Title: Source State Diagram Applied to: USB Power Delivery Specification Revision 2.0 Version 1.2 Brief description of the functional changes: Revision 3.0 Source state diagram which had been incorrectly integrated into Revision 2.0 and has been replaced with the correct version. Updates to note numbering. Additions and amendments to textual descriptions to match diagrams. Benefits as a result of the changes: Diagrams match operation as defined elsewhere in the specification. An assessment of the impact to the existing revision and systems that currently conform to the USB specification: Aligns specification with the requirements expected on publication of the specification. An analysis of the hardware implications: None. An analysis of the software implications: None.

USB Power Delivery ENGINEERING CHANGE NOTICE Actual Change

Figure 8-42 Source Port Policy Engine state diagram

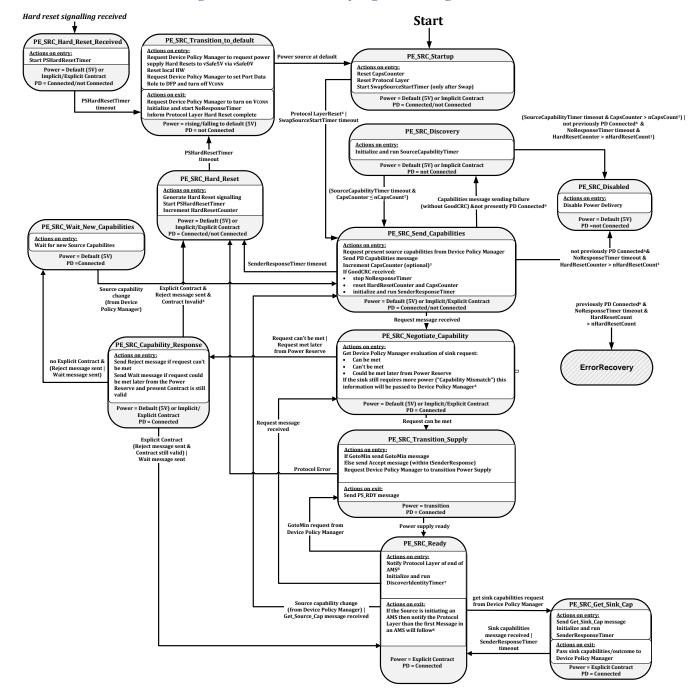
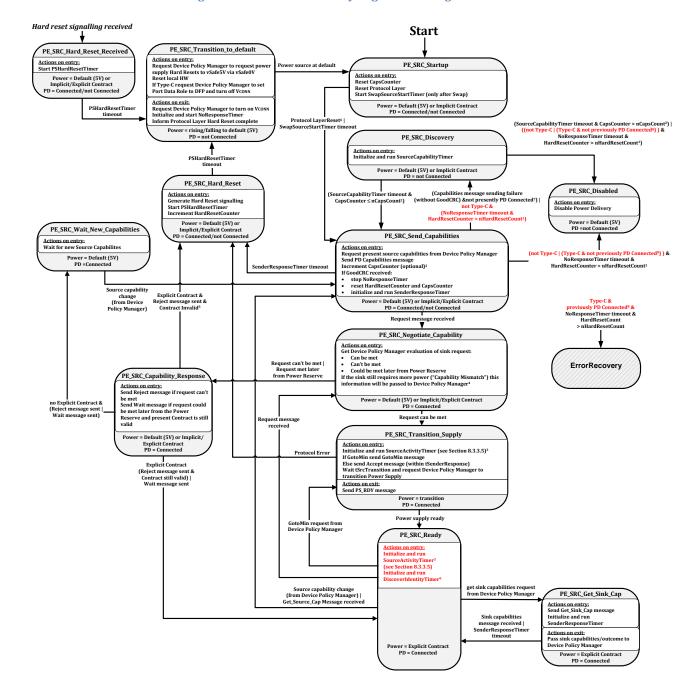
(a). Section 8.3.3.2, Page 398, Figure 8-42
